AGENDA

ARCHITECTURAL REVIEW BOARD MEETING
CITY HALL, 385 SOUTH GOLIAD STREET, ROCKWALL, TEXAS
AUGUST 25, 2026 IN THE CITY COUNCIL CONFERENCE ROOM AT 5:00 PM

PROJECT NUMBER: SP2026-031
PROJECT NAME: Site Plan for 1041 E. Interstate 30
SITE ADDRESS/LOCATIONS: 1041 East Interstate 30, Rockwall, TX, 75032

DEPARTMENT	REVIEWER	DATE OF REVIEW	STATUS OF PROJECT
PLANNING	Bethany Ross	08/20/2026	Approved w/ Comments

4 WEST ELEVATION

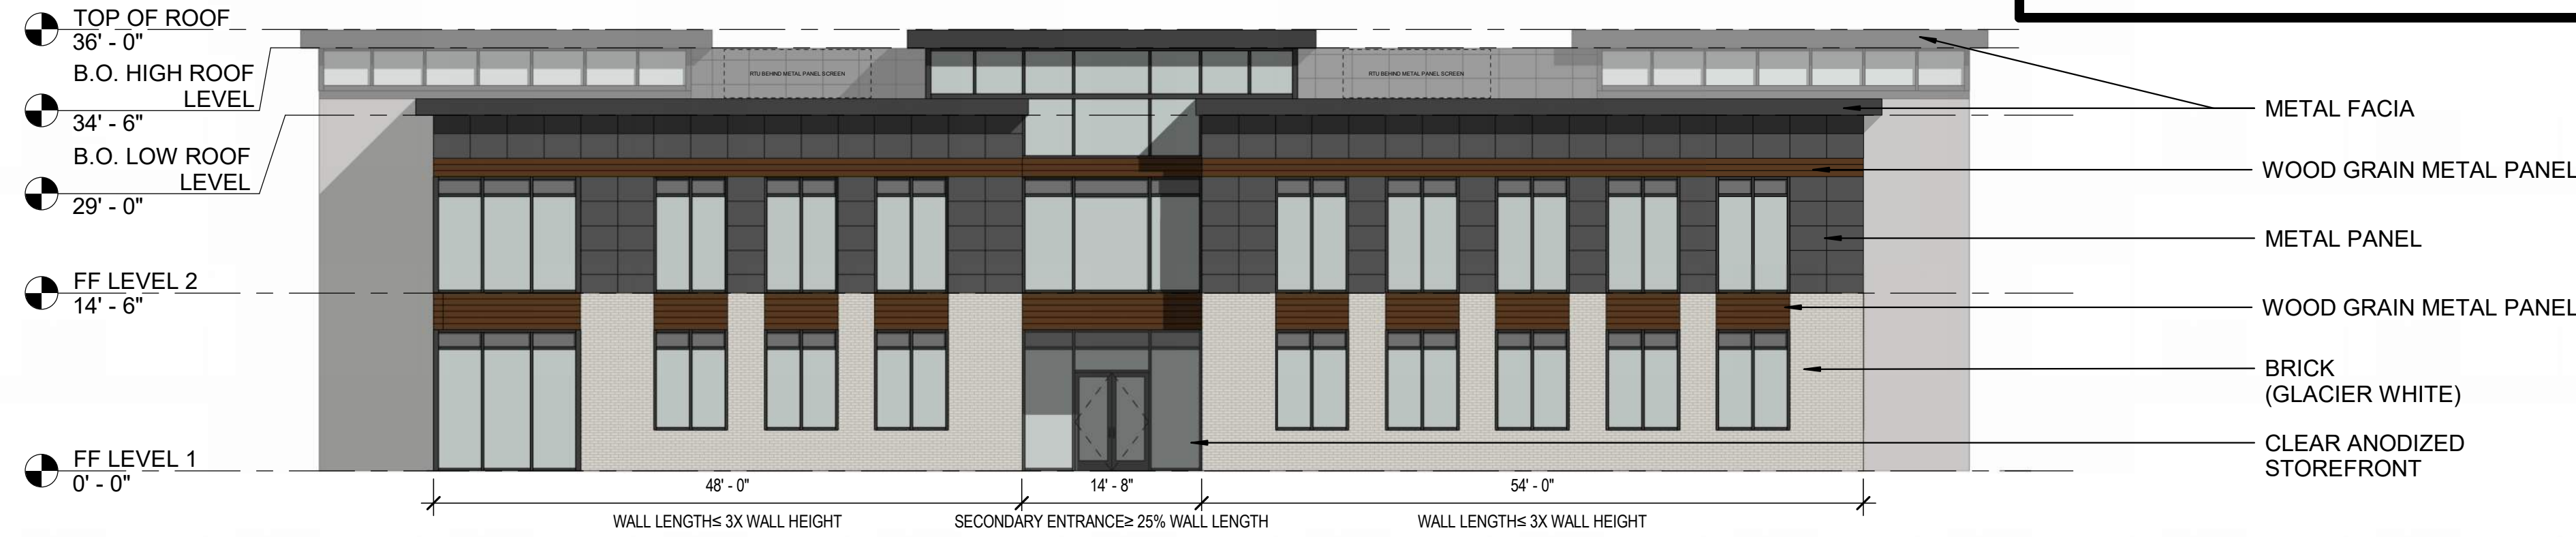
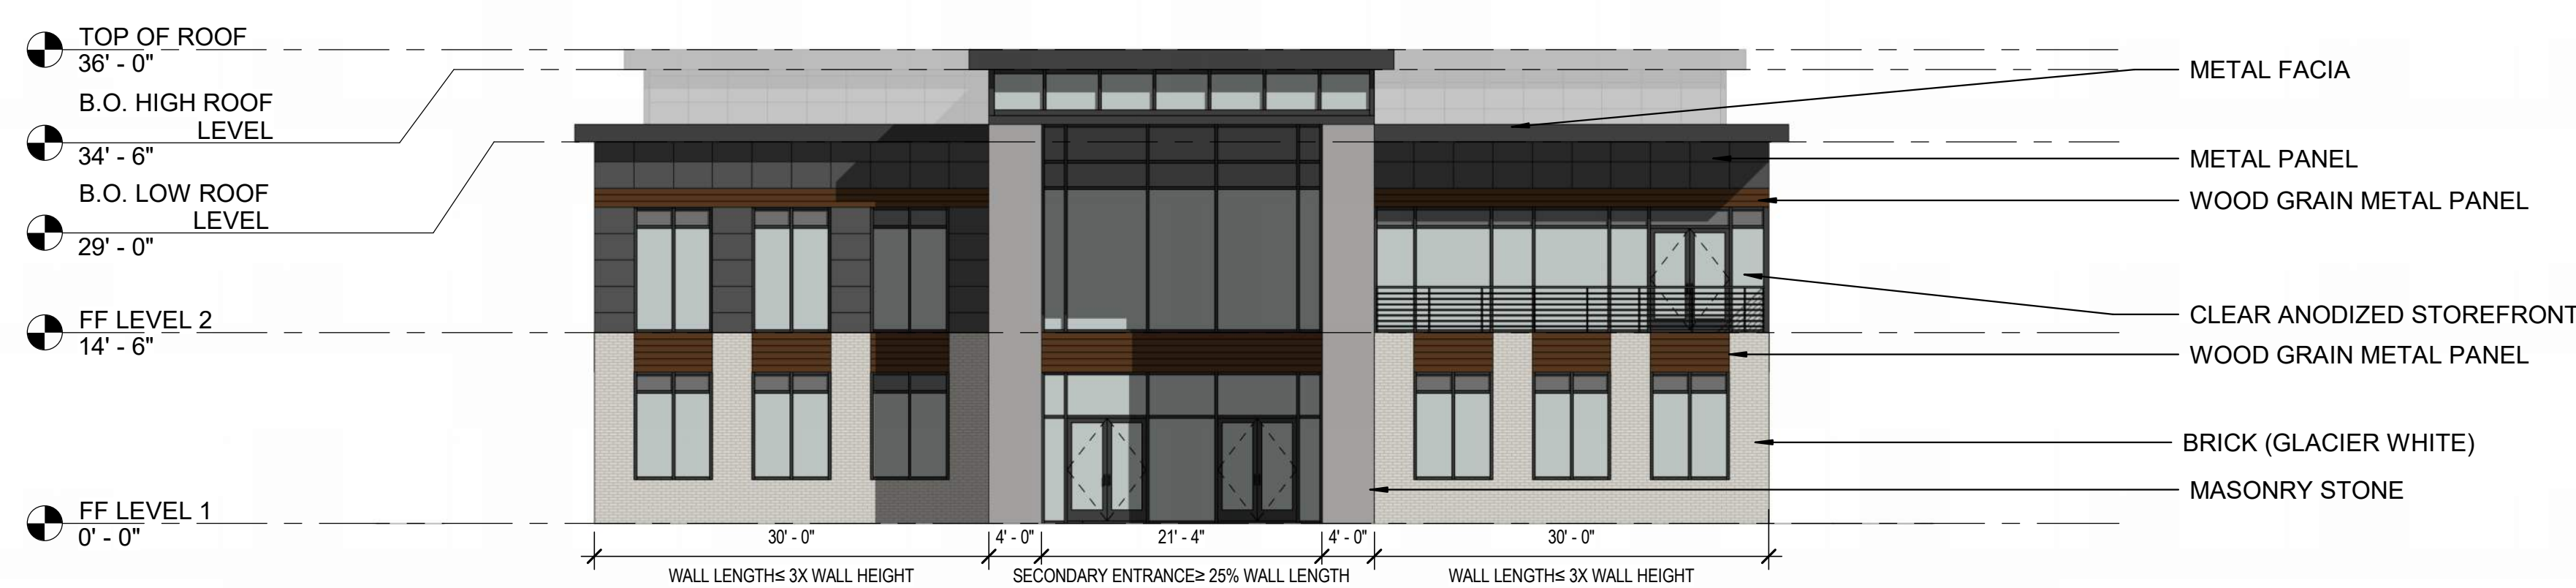
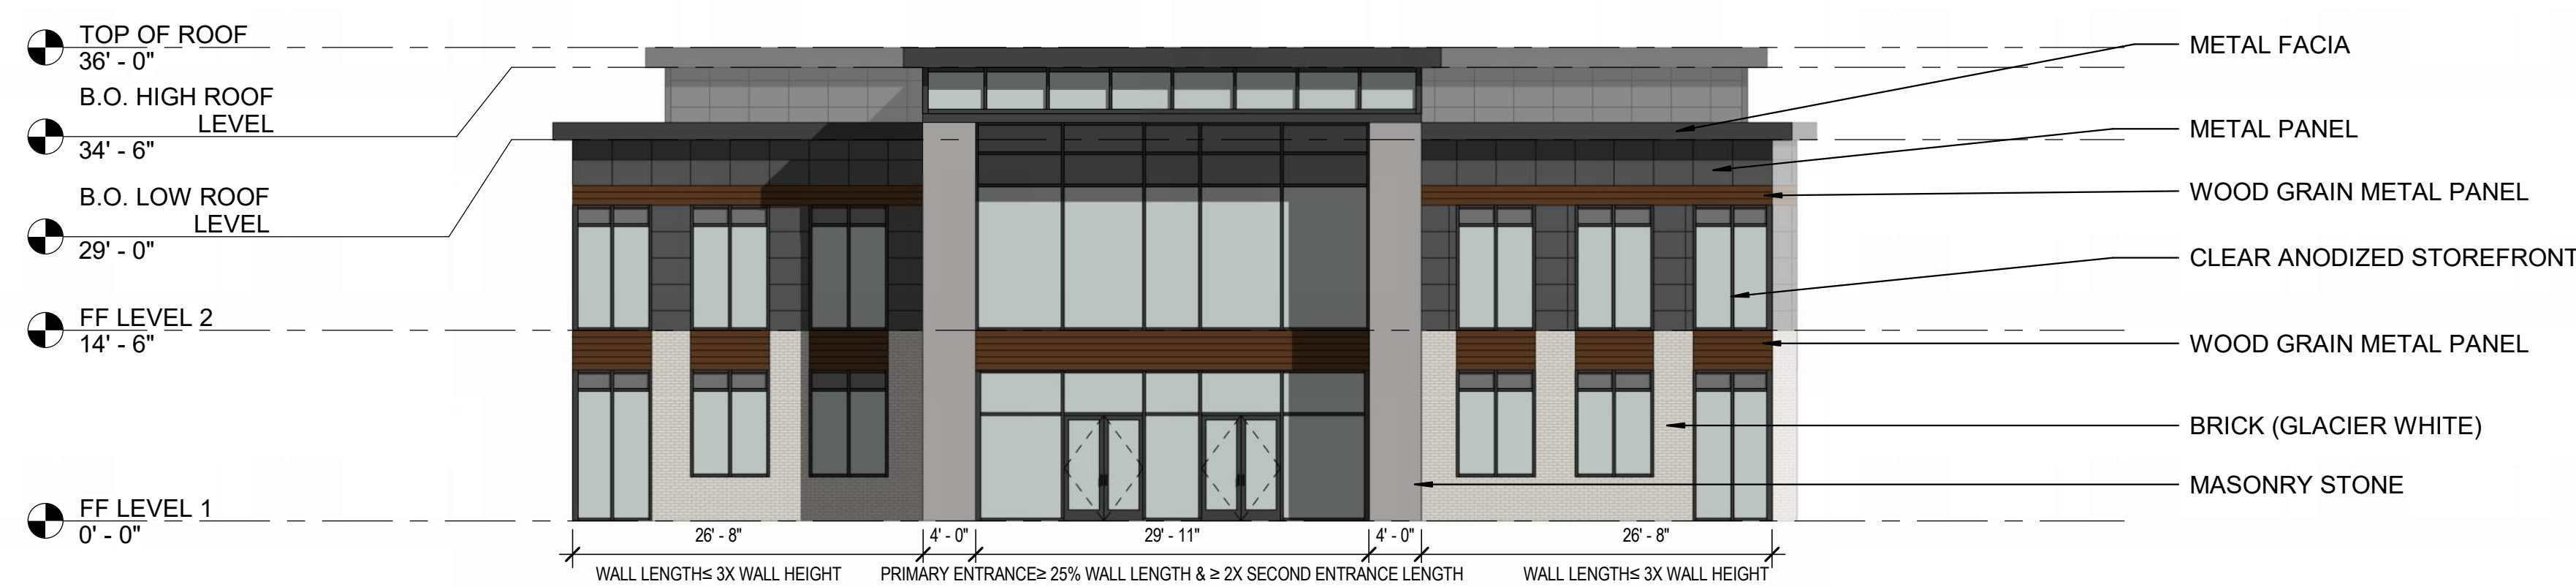
- (2) *Building Articulation*. According to Subsection 04.01, *General Commercial District Standards*, of Article 05, *District Development Standards*, of the Unified Development Code (UDC), each building façade within a Commercial (C) District must meet the minimum primary and secondary articulation standards. In this case, the proposed buildings do not meet the articulation standards; however, this is not atypical for buildings of this size. This will require an exception from the Planning and Zoning Commission.

On July 28, 2026, the Architectural Review Board (ARB) reviewed the *Building Elevations* provided by the applicant. The Board recommended that the applicant soften the elevations to provide a transition from the nearby residential. The Board will review the updated elevations at the August 25, 2026 Architectural Review Board meeting prior to the Planning and Zoning Commission meeting.

LANDSCAPE PLAN

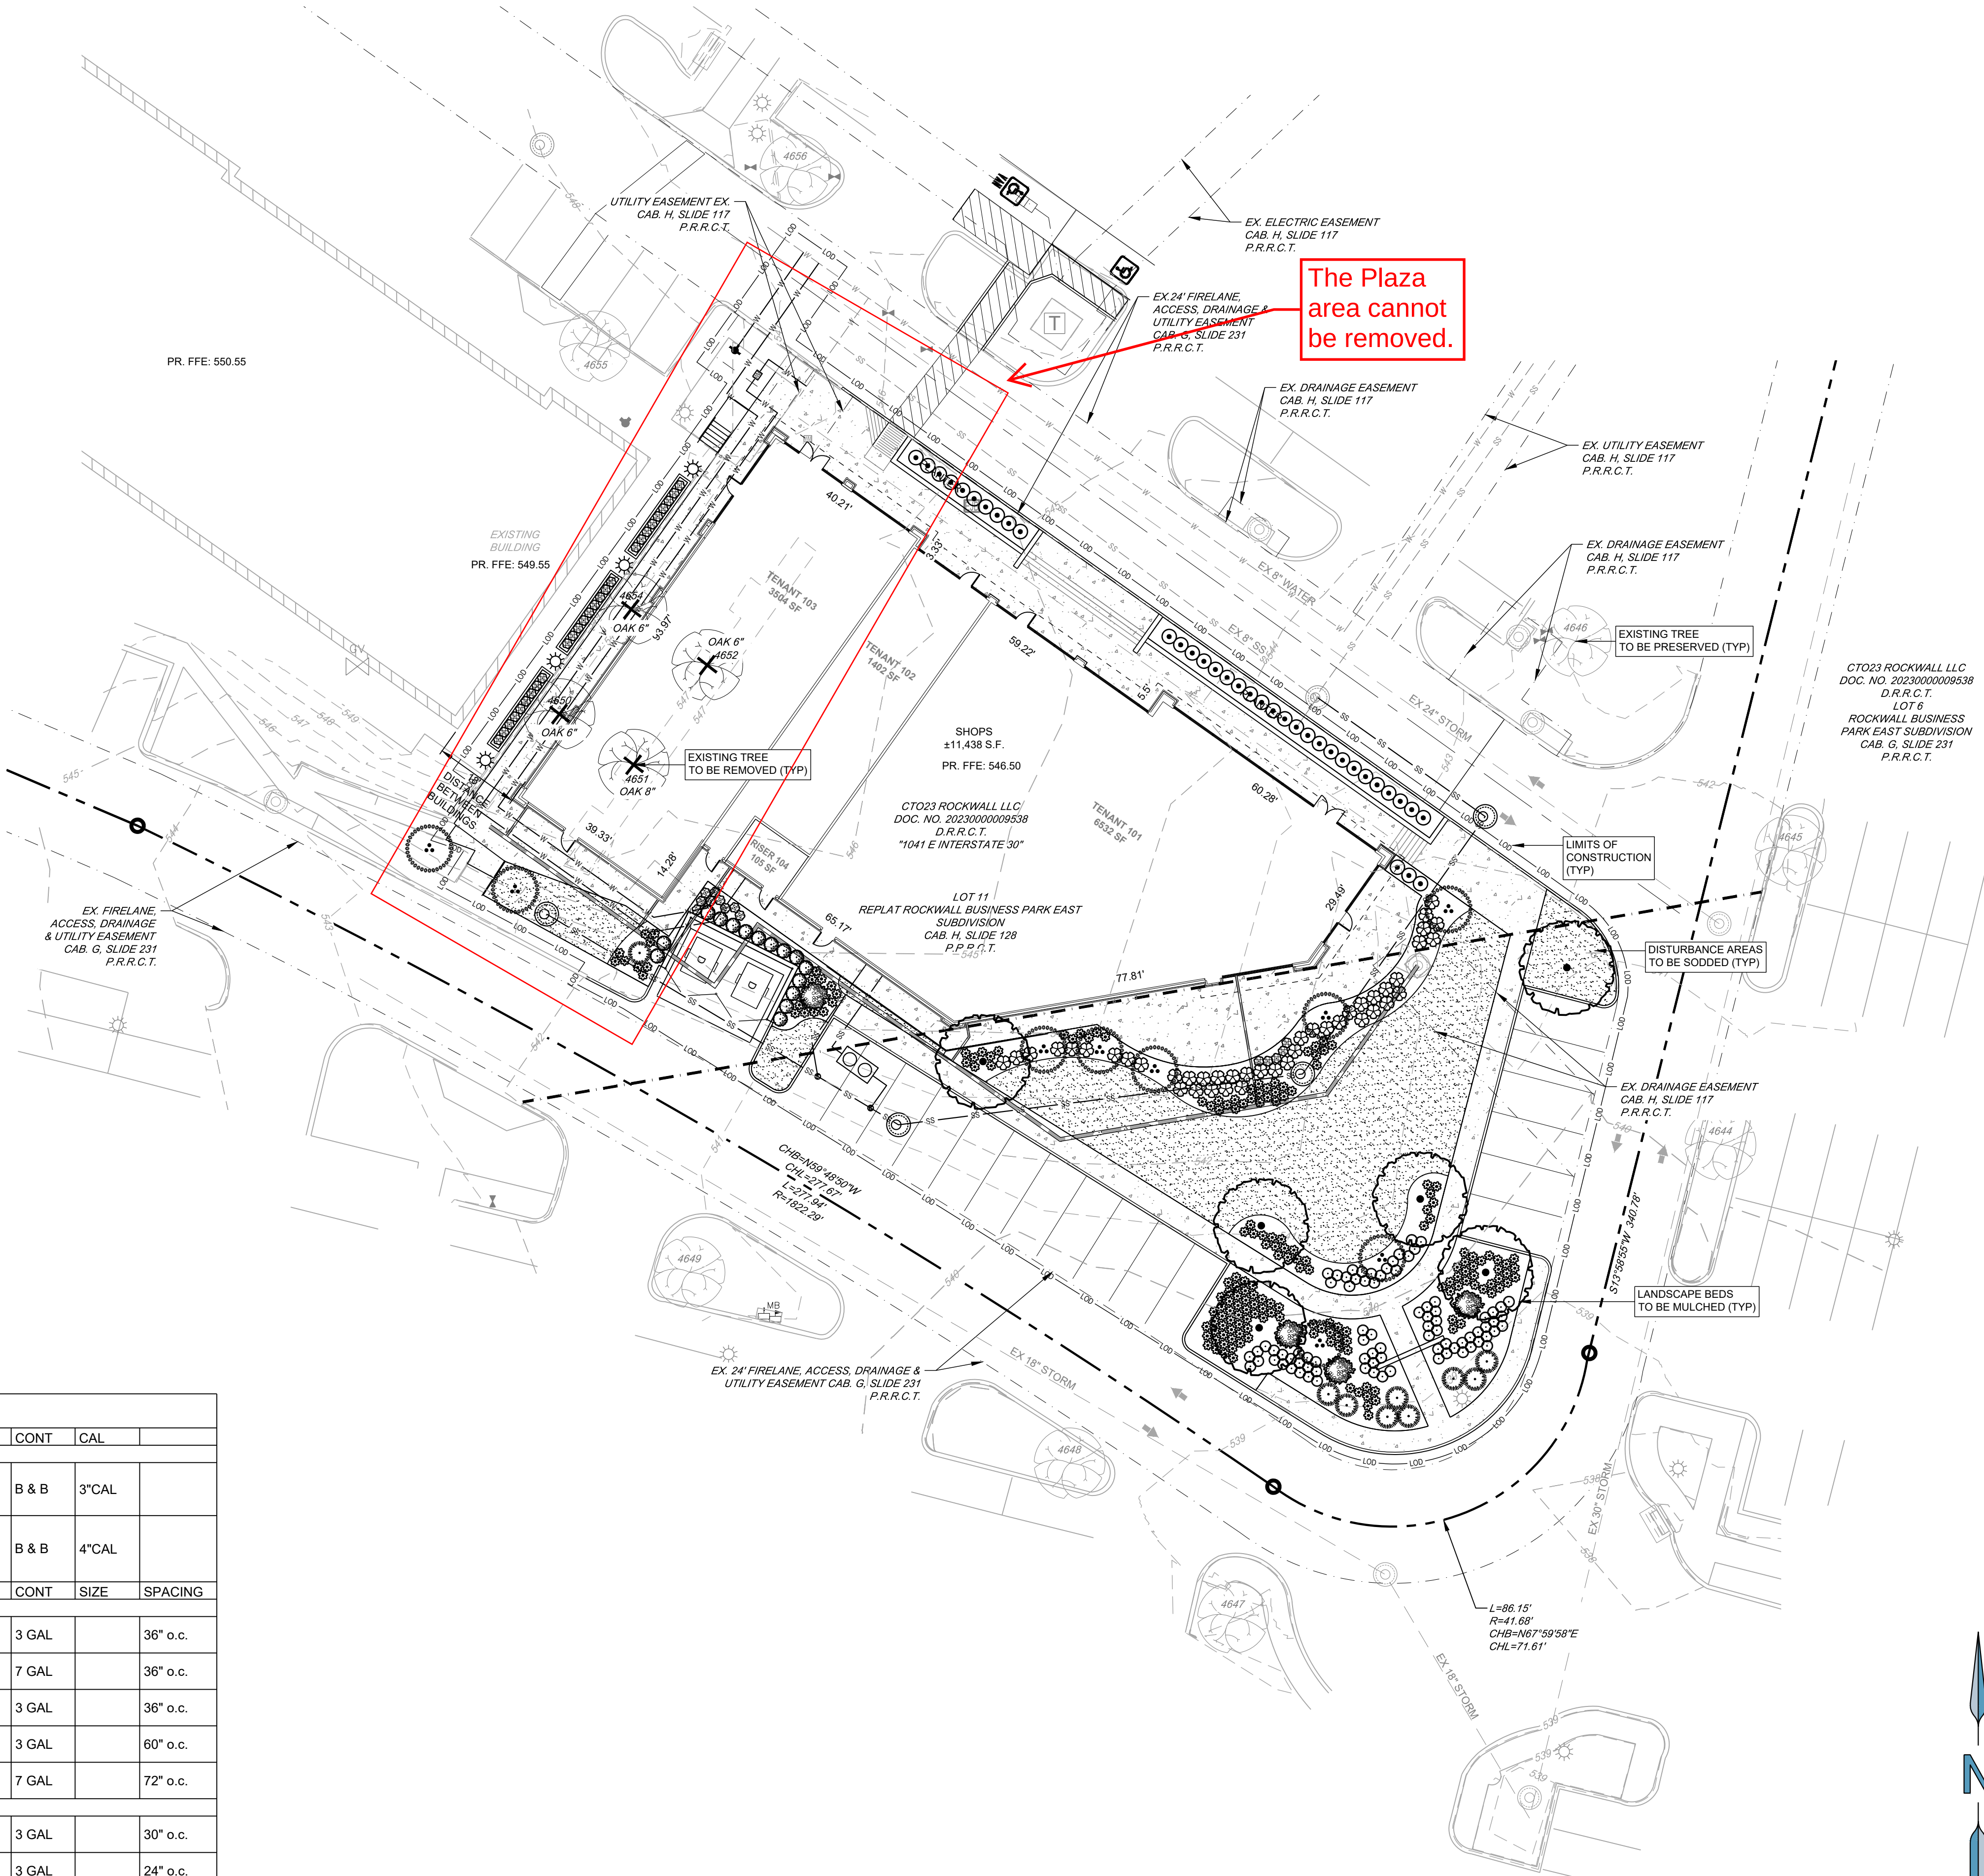
M.8 Landscape Plan

- 1) Pad mounted utility equipment shall be screened from view using evergreen shrubs. (Subsection 01.05.C, Article 05, UDC).
- 2) Again, the plaza area cannot be removed. It was a part of a previous site plan (i.e. SP2010-007 & SP2013-003) approval and associated with variances to the code. Please correct this and show required plantings.
- 3) All shrubs must be 5-gallon or larger. (Subsection 06.02.E.2, Article 05, UDC)
- 4) Irrigation is required for all plantings. Provide a note indicating irrigation will meet requirements of the UDC. (Subsection 05.04, of Article 08, UDC)

DEPARTMENT	REVIEWER	DATE OF REVIEW	STATUS OF PROJECT
PARKS	Travis Sales	08/17/2026	Approved w/ Comments
08/17/2026: 1. Tif Tuf and Tahoma 31 are better varieties than Tifway 419. They are more drought, cold, shade and wear tolerant (informational only) 2. please add more trees in the area at the southeast corner
